MCLAREN TRAFFIC ENGINEERING

30 July 2020

Reference: 190510.05FB

LETTER OF RESPONSE TO COUNCIL COMMENTS FOR MIXED USE DEVELOPMENT AT 90-98 GLENMORE RIDGE DRIVE, GLENMORE PARK

TWO WAY PASSING AROUND SOUTH-WESTERN BEND ON GROUND LEVEL CAR PARK

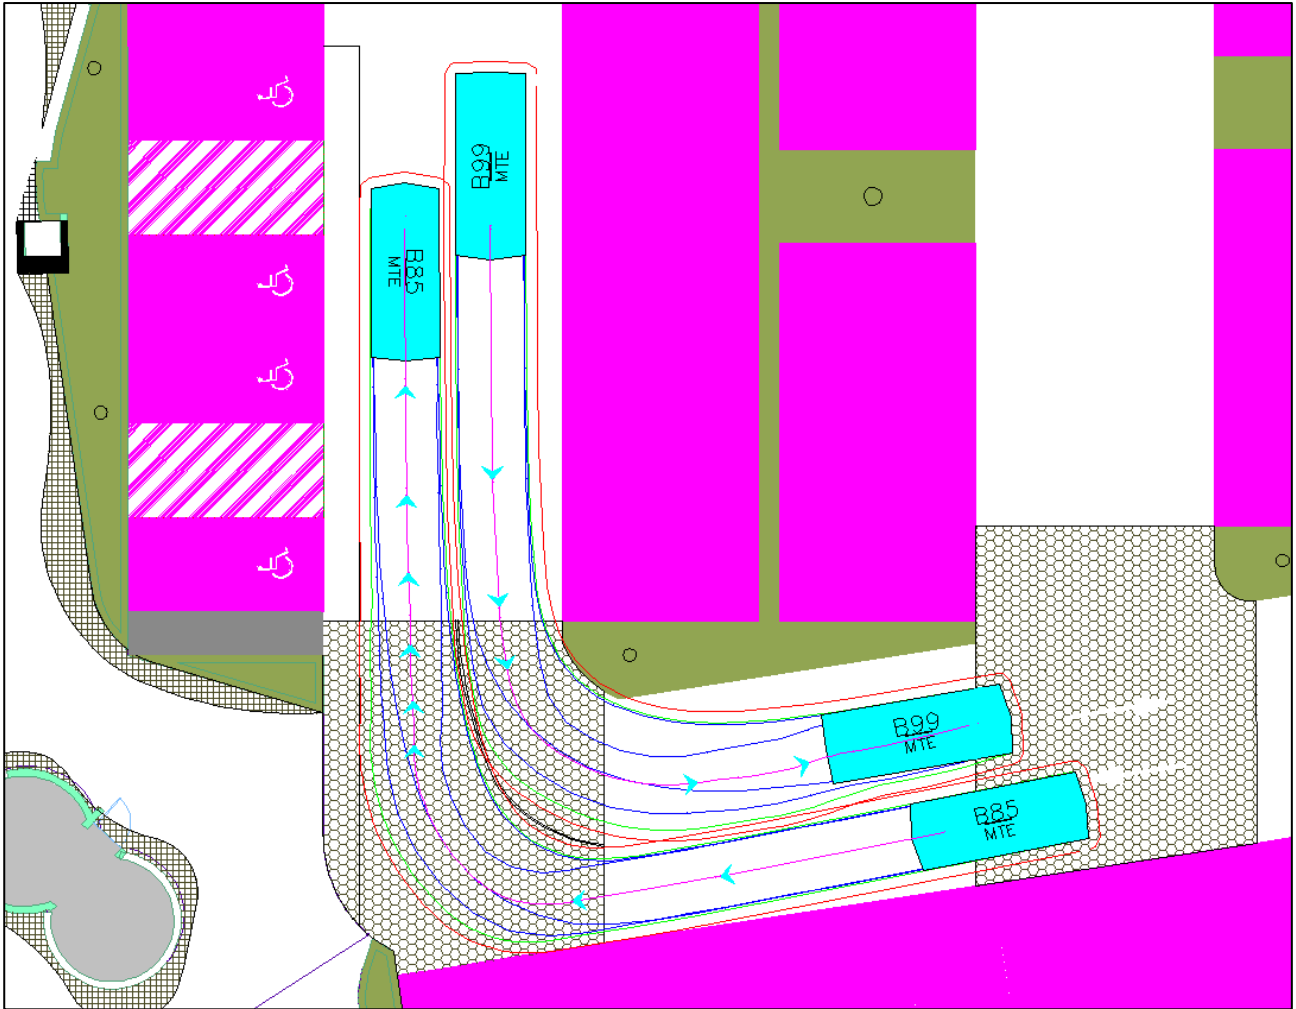
3. The acute bend at the south-western corner of the at-grade car park shall be redesigned to be no less than 90 degrees to avoid corner cutting. The Traffic Letter has provided turning paths to demonstrate that two-way passing can be achieved around the bend, however the turning paths conflict with the pedestrian path of travel for accessible parking which isn't considered appropriate. The acute bend shall be redesign accordingly.

The plans have been updated in order to accommodate two-way passing around the subject bend whilst not entering the line-marked pedestrian path. Swept path testing has been conducted as shown in **Annexure B** depicting this provision.

Successful – Satisfies Council's Comment.

Subject to low lying landscaping within 300mm of traffic aisle.

Note: Vehicle body and clearance does not enter line-mark pedestrian path.
